**From:** "Vickie" <vickie.allen@imssystemsincl.com>  
**To:** "Bill Ward" <wrw1@nrc.gov>  
**Date:** Fri, Oct 6, 2000 9:48 AM  
**Subject:** Fw: NRC / Nucor C98-22-007

Subject: NRC / Nucor C98-22-007

**Spiralfeder 0021-071-01**

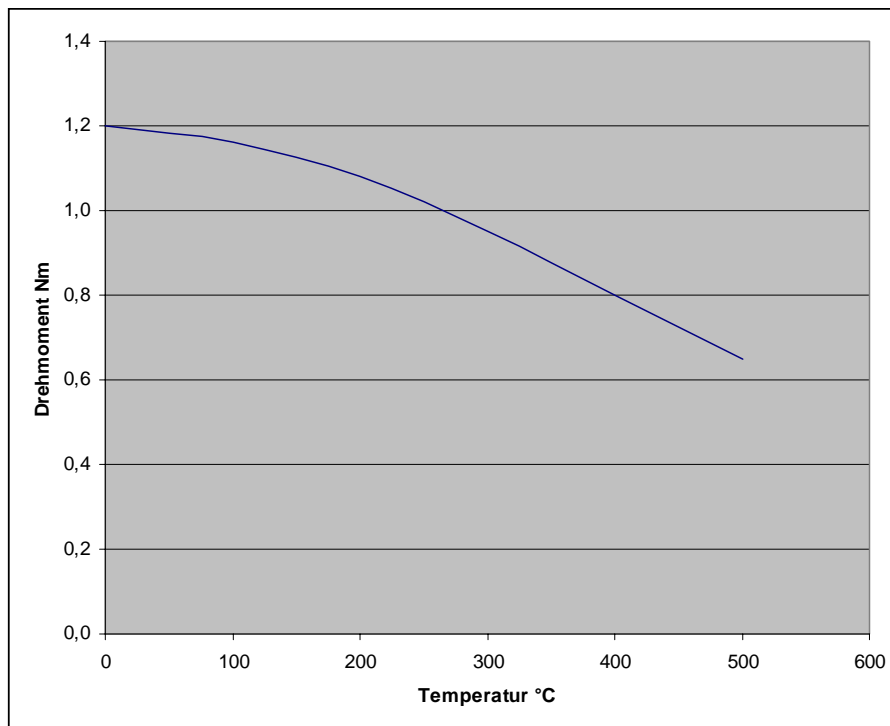
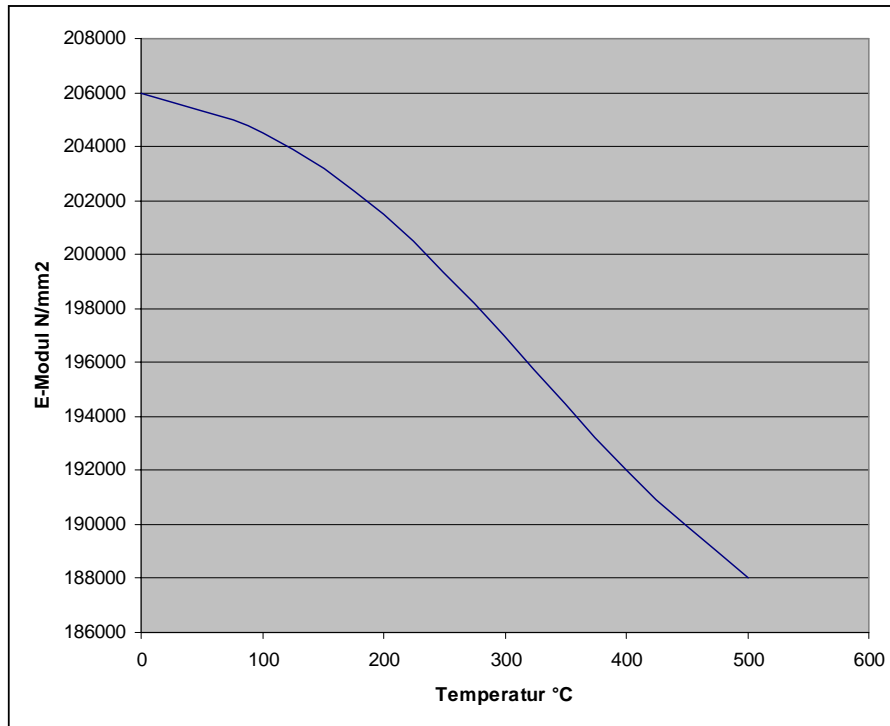
Enclosed is the final question that you have requested. If you need any thing further please call.

>  
>  
>  
>  
> Christoph Hollands@IMS  
> 06.10.2000 17:26  
>  
> Hey Vickie,  
>  
> ca. / max 0.7 Nm it dependent a littlebit of the bearings age.  
>  
> I hope realy that was the last question !  
>  
>  
> Mit freundlichen Grüßen  
> Christoph Hollands  
> IMS GmbH  
>  
>  
>
